HISTORIC PRESERVATION BOARD STAFF REPORT

98 NW 5th Avenue

Meeting	File No.	Application Type
October 7, 2020	2019-261	Class III Site Plan & Certificate of Appropriateness

FRONTAGE STANDARDS, MINIMUM STREETScape WIDTH

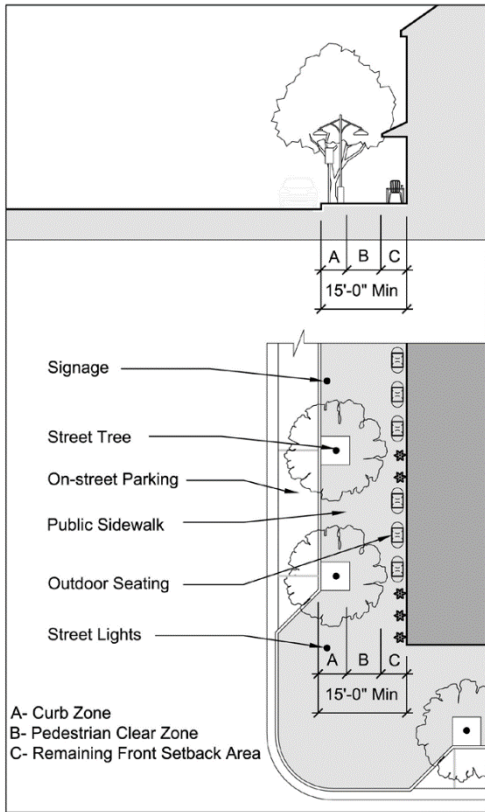
The subject property has frontage along NW 5th Avenue (east side) and NW 1st Street (north side). There is a five-foot right-of-way dedication required along NW 5th Avenue and a 1'6" alley right-of-way dedication required along the north/south alley in the rear of the property. On the north side of the property, a 10' easement is proposed along NW 1st Street. While the site plan indicates that the requirements of the code can be met as there is sufficient space to accommodate the required streetscape, the dimensions are incorrectly illustrated on plan sheet AS-102 as 7' is dimensioned rather than 4' along NW 1st Street. An added condition of approval is that the site plan be updated to correctly illustrate the required 4' Curb Zone along NW 1st Street.

1. That the plan sheet AS-102 and any associated plan sheets be updated to correctly illustrate the required 4' Curb Zone along NW 1st Street.
2. That street trees be located within the Curb Zone of the adjacent NW 1st Street right-of-way;
